Great Lakes UK Limited
Great Wolf Lodge, Chesterton, Bicester

Non Material Amendment (S.96a) Application
Design Changes

March 2023

Proposed Amended Scheme - Conference Centre & Waterpark

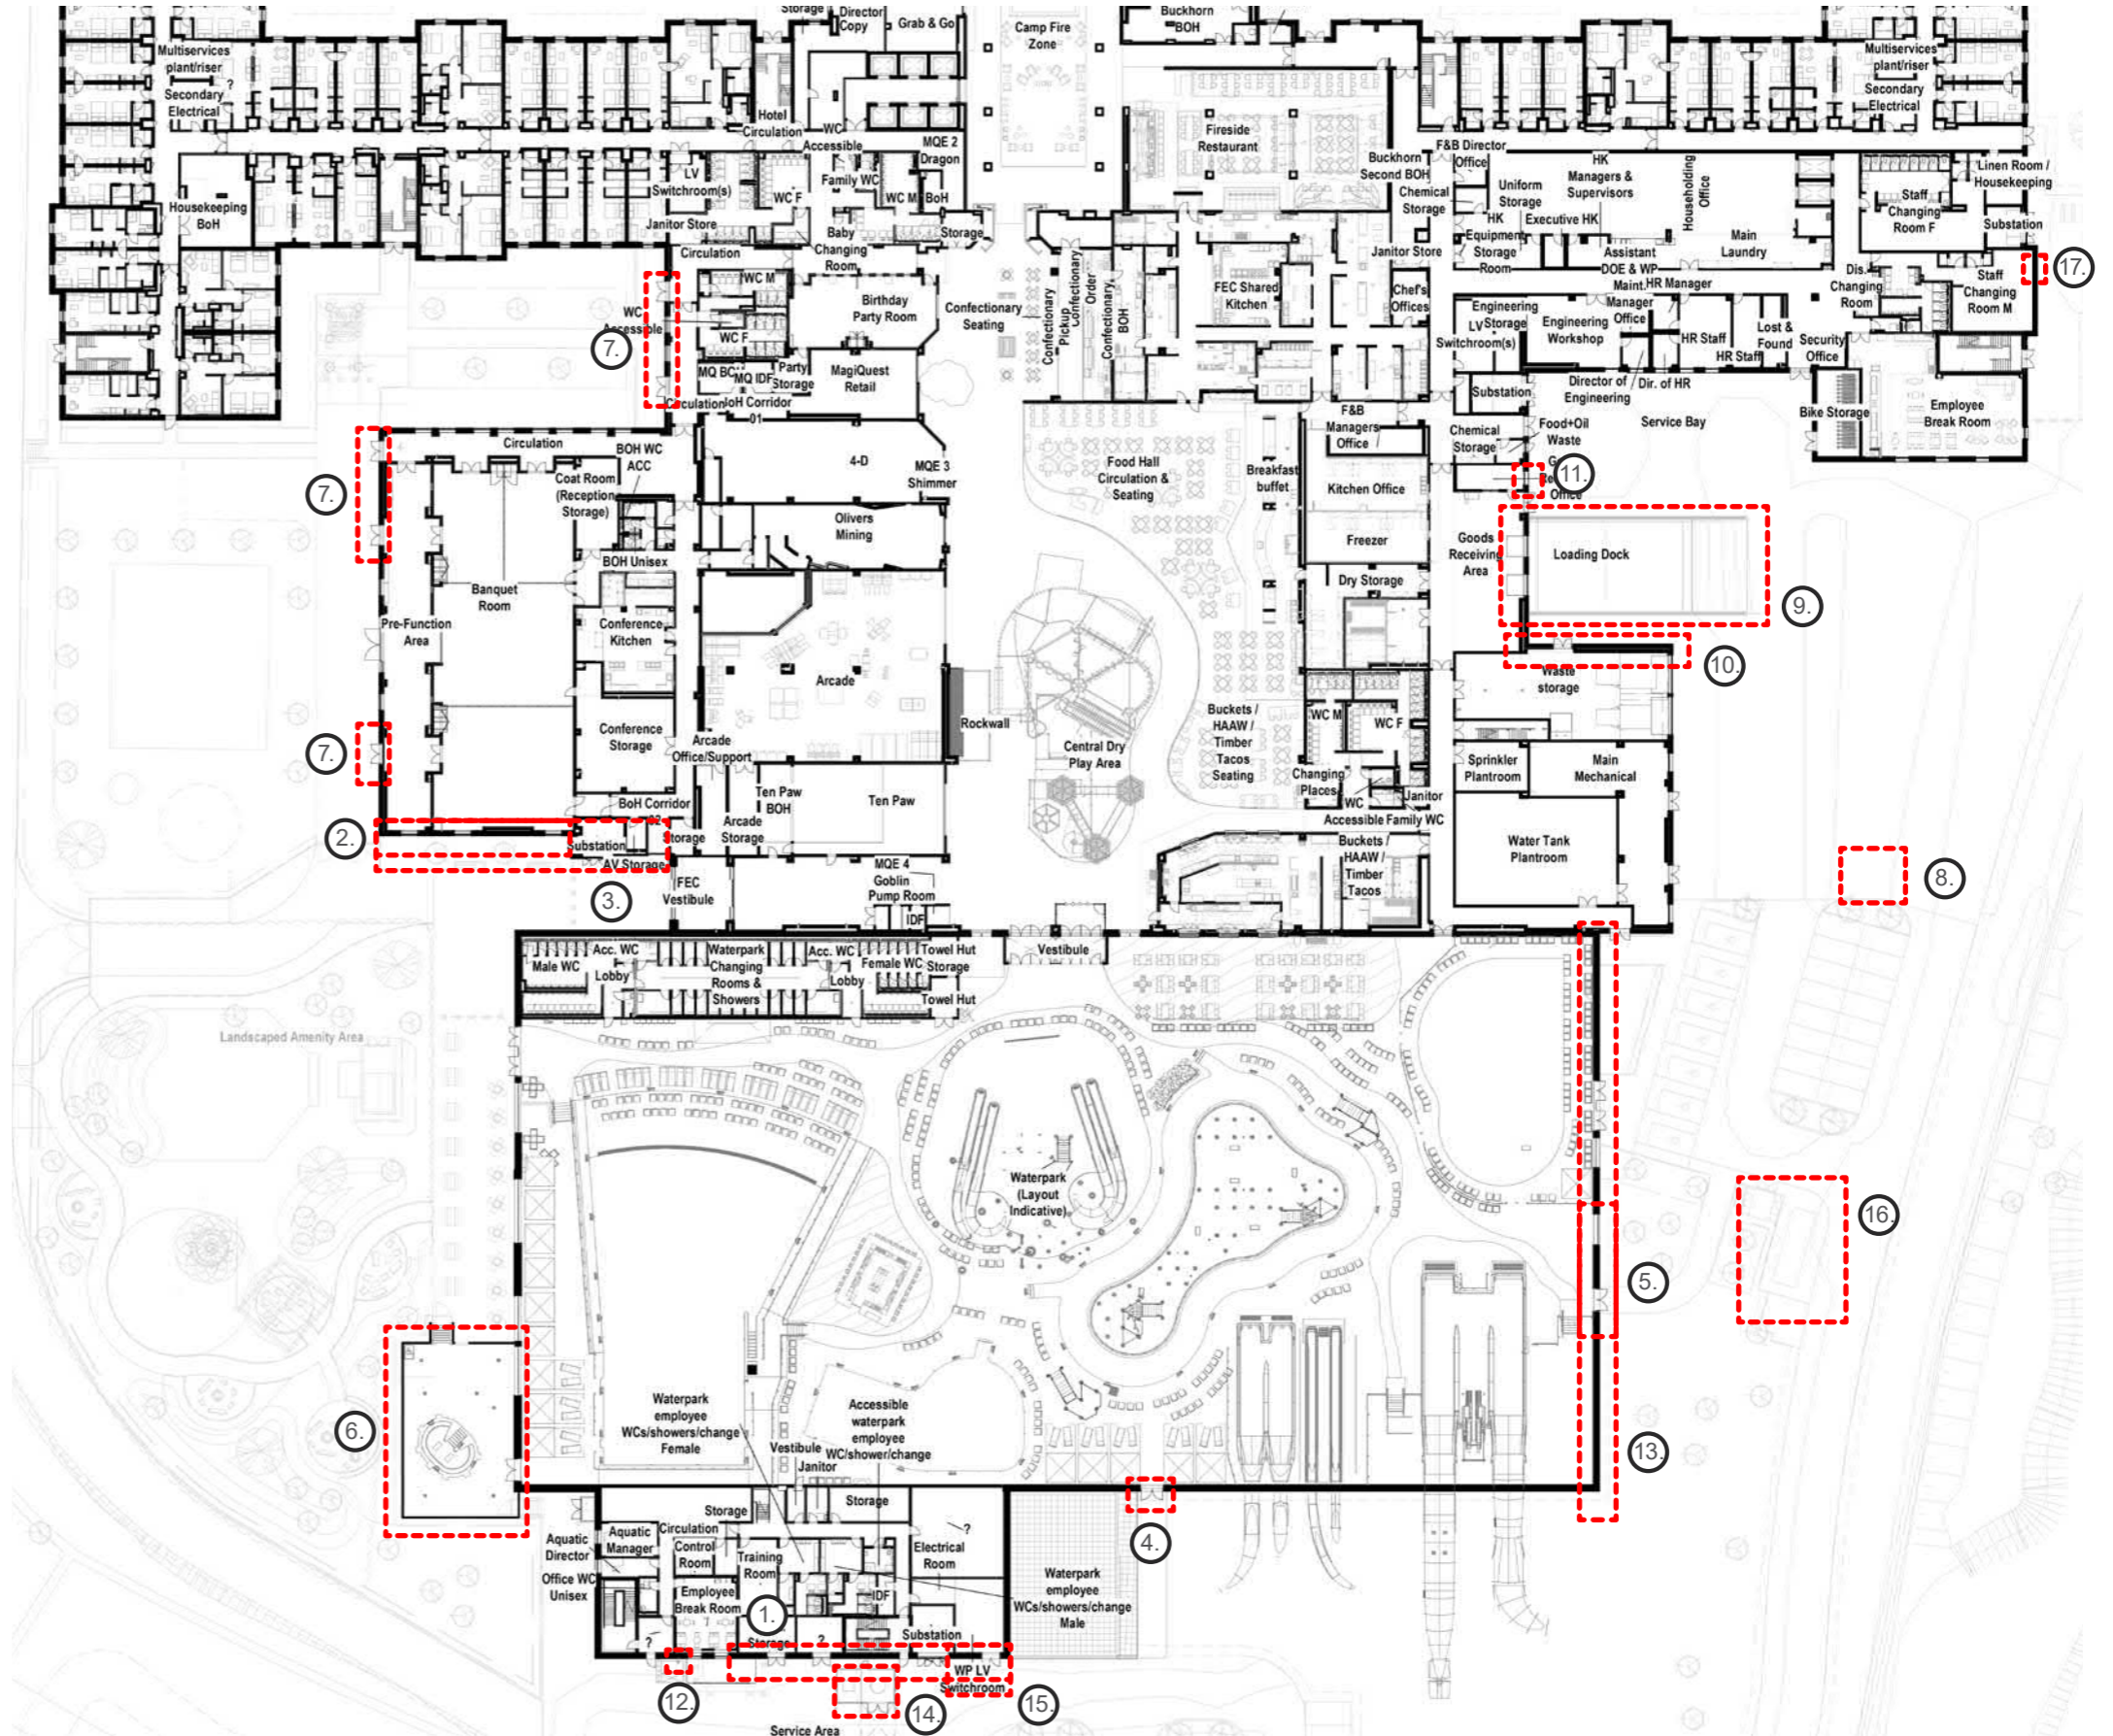
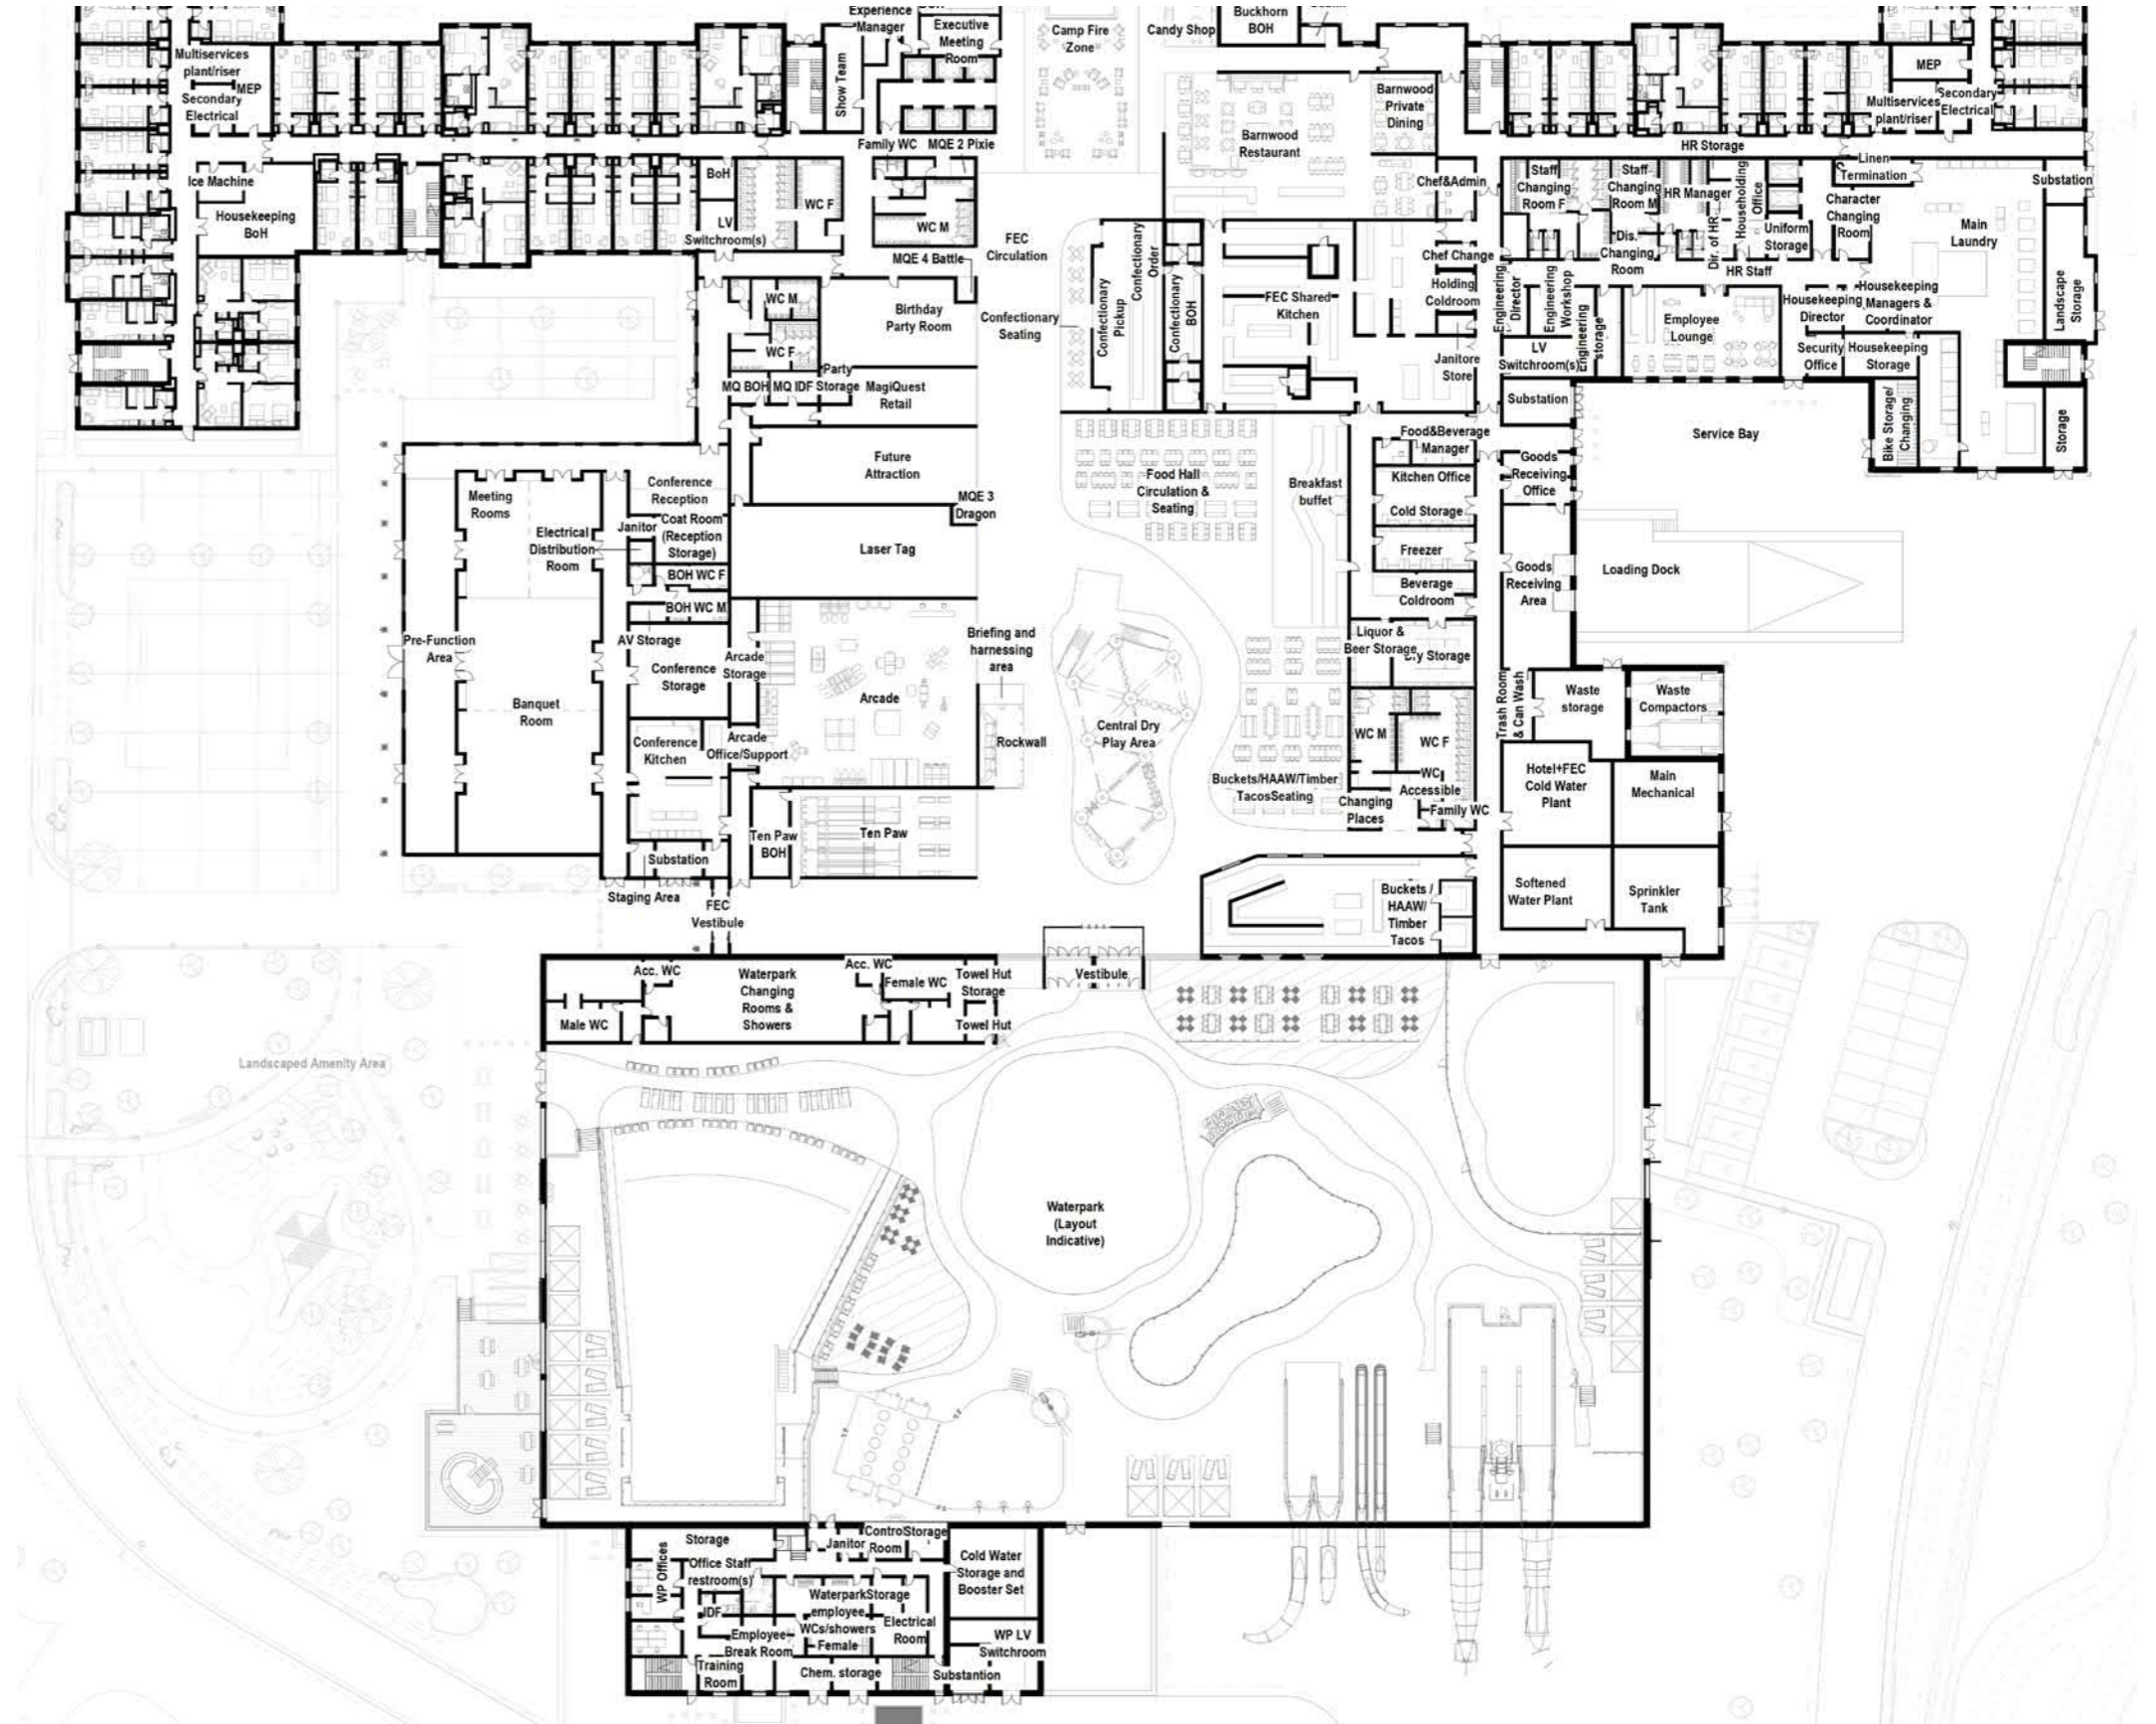
1. Bunker Door and louvre position updated + windows removed to chemical store.
2. Additional windows added to conference centre and timber cladding extended up.

3. Continue timber up to render and omit the tiling and associated vertical supports.
4. Additional external door added to east side of waterpark for fire means of escape purposes.

5. Roller shutter door move and fire escape door moved to south east elevation.
6. WP raised external hot tub area reduced in size from previous permission.

7. Windows and doors at the conference centre link corridor reduced in size to adjust to the window height.
8. New card board bailer location for bailed cardboard to be stored in an enclosure away from the building for fire safety.

9. Minor movement of the vehicle loading ramp.
10. External wall position to north of compactor / waste room moved north.
11. Omission of door to the food oil & waste room.

12. New gas pipe added to the bunker building up the external envelope.
13. Omission of brise soleil from south eastern gable elevation of waterpark
14. Changes to size of CO2 tank behind bunker and associated enclosure.

15. Plant replacement door on 2nd floor Bunker plant room moved and changed to roller shutter door.
16. New diesel exhaust to be added to free standing generator.

17. Omission of window to staff changing room.
